Landscape Review Committee Community Development Center, 231 NE 5th Street February 19, 2020 12:00 PM

SUBJECT: Agenda Item 4A – Landscape Plan Review Application (L 32-19)

DECISION, CONDITIONS, FINDINGS OF FACT AND CONCLUSIONARY FINDINGS FOR THE APPROVAL OF A LANDSCAPE PLAN REVIEW AT 2019 NE HIGHWAY 99W

DOCKET: L 32-19 (Landscape Plan)

Figure 5: Proposed Landscape Plan

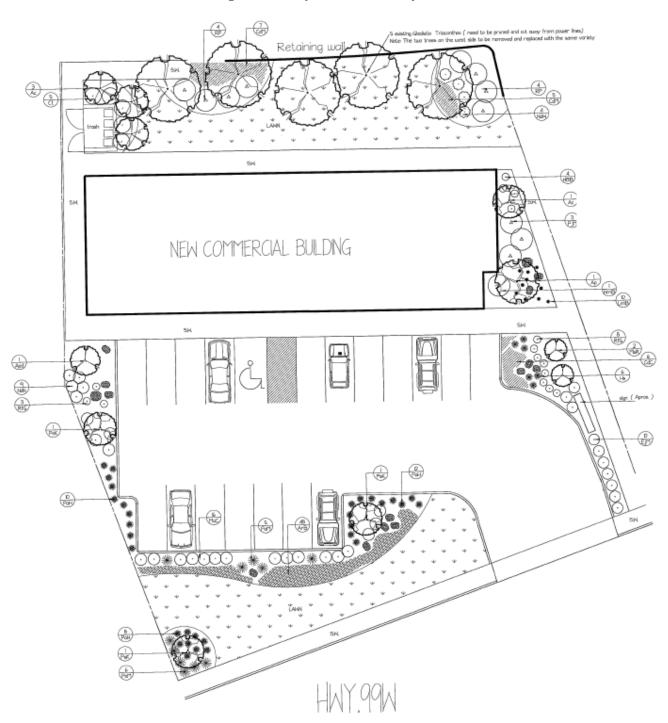
The applicant's landscape plan proposes a large percentage of landscaping on the site (24 percent) which is considerably more landscaping and non-pervious area than currently exists on the site. Groupings of trees and shrubs meet many of the planning factors above and help achieve the purpose of the landscape chapter of MMC. Specifically, the plan features parking lot perimeter planting, perimeter planting around portions of the proposed commercial building, the retention of most of the existing mature trees along the northern property line, and supplemental plantings.

Issue	Notes	Condition to Help Meet Criteria
Retention of existing trees	Three (3) of five (5) existing mature Honeylocust trees along NE 27 th Street are proposed to be retained	N/A
Parking lot islands and planting	Planting proposed for the perimeter of the parking area, but no internal islands/planting proposed	Condition of Approval #3: Requires an internal parking lot island with planting in the northern parking aisle
Use of suitable street trees	Street trees not required	N/A
Irrigation system or water facilities	Landscape areas to receive automatic irrigation system.	N/A
Landscaping req'd around trash enclosure	Landscaping not provided on 3 sides of trash enclosure	Condition of Approval #4: Requires planting on third side of trash enclosure

- 1. That the applicant shall install landscaping as shown on the landscape plan submitted to the Planning Department on December 23, 2019.
- 2. That if any of the five (5) existing *Gleditsia triacanthos* (Honeylocust) trees are removed, they shall be replaced with a tree species from the McMinnville Street Tree List Recommended Small Tree Species approved for planting under overhead wires.

- 3. That a parking lot island internal to the northern parking aisle and plantings therein shall be provided. Such landscaped islands shall have raised curbs, be a minimum five (5) feet in width, and shall contain at least one (1) deciduous tree.

- 4. That landscaping be provided around a third side of the trash and recycling enclosure. Climbing vines and screening shrubs are appropriate, and plant material must be a minimum of three (3) feet in height at the time of planting.

- 5. That the applicant shall maintain proper clearances around the existing and future water and electrical services that will be located on the site. Landscaping shall not be placed within four (4) feet of fire hydrants, within four (4) feet of water valves, within four (4) feet of vaults, within three (3) feet of the back or side of a transformer, or within one (1) foot of water meters. Minor adjustments in plant placement from the locations shown on the approved landscape plan are allowed if relocation is necessary to meet minimum clearances.

Figure 8: Proposed Parking Lot Perimeter Landscaping (Highway 99W)

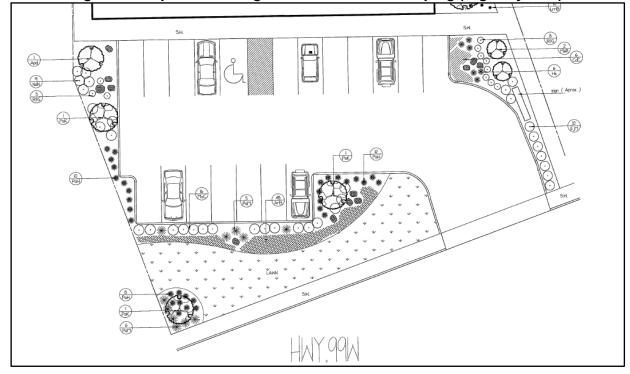
Landscaping is proposed around the east, south, and west sides of the off-street parking lot. To the south along Highway 99W, a large lawn area is proposed. A planting island in the southwestern corner of the lawn is proposed with a *Prunus serrulata 'Kwanzan'* (Kwanzan Japanese Flowering Cherry) and several ornamental grasses. Adjacent to the parking lot, the landscape area features ornamental landscape boulders, native evergreen *Mahonia aquifolium 'Compacta'* (Compact Oregon Grape) shrubs, ornamental *Pennisetum alopecuroides 'Hameln'* and *'Maudry'* (Hameln and Moudry Fountain Grass) grasses, *Ajuga reptans 'Burgundy Glow'*

West of the parking lot are more of the same ornamental grasses and landscape boulders and another Kwanzan Japanese Cherry Tree. Additionally, clusters of evergreen Nandina domestica 'Purpurea' (Purpurea Heavenly Bamboo) shrubs and flowering perennials are interspersed in the planter. An *Acer palmatum dissectum 'Crimson Queen'* (Crimson Queen Japanese Maple) is also proposed in this area.

East of the parking lot and driveway, a planting area is proposed that continues the planting theme. Ornamental grasses, lowering perennials, groundcover, and evergreen *Euonymus japonicas 'Microphyllus'* (Boxleaf Euonymus) are proposed in addition to two small *Magnolia stellata 'Rosea'* (Rosea Star Magnolia) trees.

Figure 10: Landscaping Along NE 27th Street

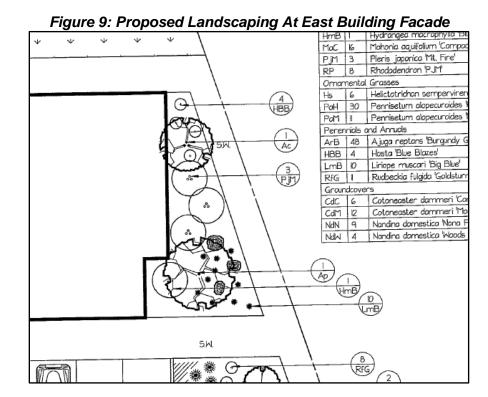
North of the commercial building, landscaping is proposed adjacent to NE 27th Street. There are five (5) existing deciduous Gleditsia triacanthos (Honeylocust) trees underneath power lines that run along the NE 27th Street right-of-way. The proposed trash enclosure is also located in this area. The three eastern Honeylocust trees are to be retained, and the landscape plan calls for replacing the two western Honeylocusts in-kind. Below the Honeylocusts, evergreen Rhododendron 'PJM' (PJM Rhododendron) and Nandina domestica 'Woods Red' (Woods Red Heavenly Bamboo) shrubs are proposed with evergreen groundcover. On two sides of the trash enclosure, evergreen Choisya ternata (Mexican Mock Orange) shrubs and Acer circinatum (Vine Maple) trees are proposed. The landscaping around the trash enclosure is addressed in more detail below. The remainder of the landscape area is a proposed turf lawn. The proposed planting will continue to provide and enhance the buffer between the commercially zoned subject site and the residential neighborhood to the north.

Honeylocust trees can grow to 30 to 70 feet tall depending on the specific variety. The variety of the existing trees is unknown. Honeylocust are generally not planted under power lines because of their mature height and growth characteristics. Continued maintentance would be required to keep the trees clear of the overhead utilities, and such maintenance is noted on the landscape plan. Because of this, replacement trees appropriate for planting under overhead utility lines is recommended to make the landscaping compatible with the utilities. A condition of approval is included to require that any of the existing Gleditsia triacanthos (Honeylocust) trees that are removed be replaced with a tree species from the McMinnville Street Tree List -Recommended Small Tree Species that is approved for planting under overhead wires.

CONDITION FOR FINDING: That if any of the five (5) existing Gleditsia triacanthos (Honeylocust) trees under the overhead utilities are removed, they shall be replaced with a tree species from the McMinnville Street Tree List – Recommended Small Tree Species approved for planting under overhead wires.

Figure 7: Proposed Landscaping Along Alpine Avenue & 9th Street

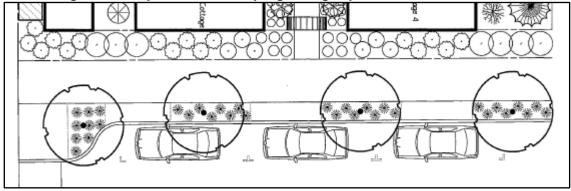
In the planter strip in the 9th Street right-of-way, *Acer rubrum 'Franksred'* (Red Sunset Red Maple) are proposed as street trees, with the small flowering perennial *Hemerocallis 'Stella D'Oro'* (Stella D'Oro Daylilly) in the tree wells. Red Sunset Red Maple is a recommended medium street tree on the McMinnville Street Tree List. Between the right-of-way and the front building line of the cottages along both 9th Street and Alpine Avenue are planting areas with a combination of lower growing shrubs, including deciduous *Berberis thunbergii 'Aurea'* (Aurea Japanese Barberry), and evergreens *Daphne odora 'Aureomarginata'* (Variegated Winter Daphne), and *Lavandula angustifolia 'Hidcote'* (Hidcote Lavender). These shrubs are easily maintained at a three (3) foot height to comply with a requirement of the Northeast Gateway District Overlay, as described in more detail below. These low shrubs will provide seasonal and aesthetic interest along the rights-of-way, helping create a pedestrian-friendly environment while maintaining visibility into the site.

Figure 8: Proposed Landscaping Along Northern Property Line

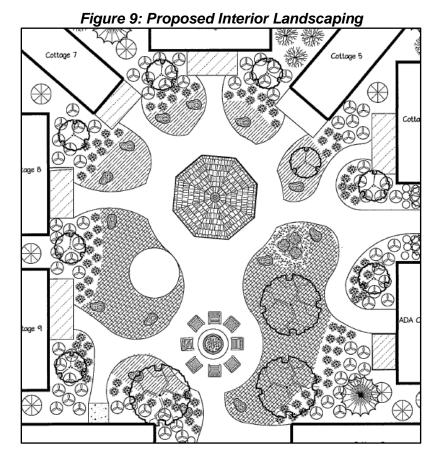
Along the northern property line of the subject site, a planting area with *Salix purpurea 'Nana'* (Dwarf Purple Osier) and *Chamaecyparis nootkatensis 'Pendula'* (Weeping Nootka Cypress) is proposed. The small Dwarf Purple Osier shrubs are planted adjacent to the cottages to allow light and visibility to the north side of the structures. Between the cottages are the Weeping Nootka Cypress trees, which can grow to 30 to 45 feet tall and 15 feet wide. These evergreen trees will help provide some screening and buffering of the interior outdoor gathering spaces from the adjacent residential use to the north.
